SI B18 05 12
Exhaust Systems

This Service Information bulletin supersedes SI 18 05 12 dated July 2012.

Voluntary Emissions Recall Campaign 11E-A03: Check and/or Replace Emissions Monitoring Components

E70 and E90 with the M57Y engine produced from April 2009 to September 2010

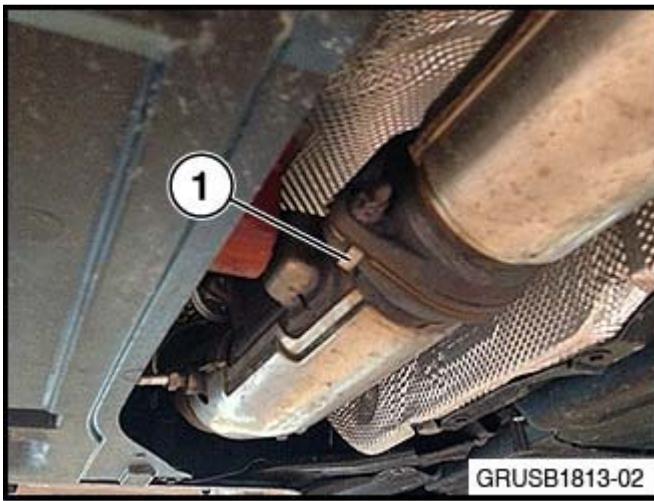
NEW 1. The E90 mixer (1) is shorter than the E70 mixer (2).

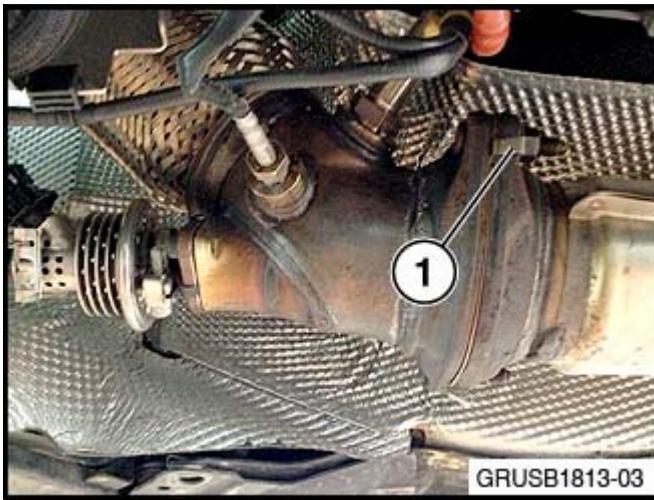
NEW 1. The barrel of the E70 mixer points toward the front of the car. This is easily identified by the mixer tabs wrapped around the front pipe flange (1).

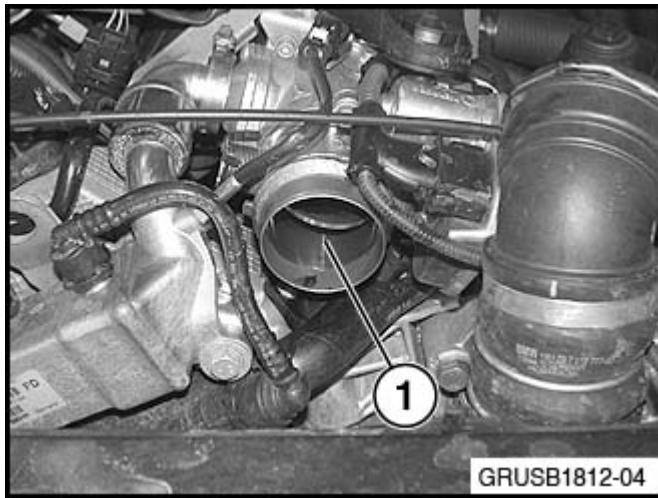
NEW 1. The barrel of the E90 mixer points toward the rear of the car. This is identified by the mixer tabs wrapped around the flange on the SCR cat (1).

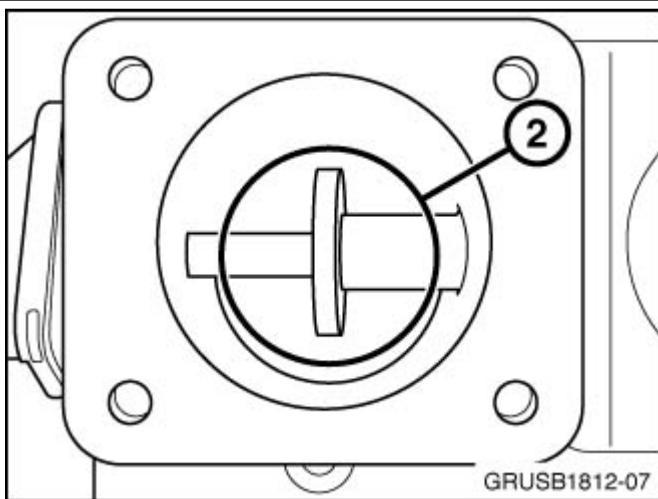
The updated EGR valve (P/N 11 71 8 517 217 or P/N 11 71 8 512 526) has the valve and seat directly in the airstream of the throttle (1). If this valve is installed, no further action is needed. Reinstall the charge air pipe.

The original EGR valve has a diffuser in the airstream flow from the throttle (2). The valve for EGR actuation is seated further into the EGR airstream. Replace this valve with P/N 11 71 8 512 526 (Repair Instruction 11 71 501).
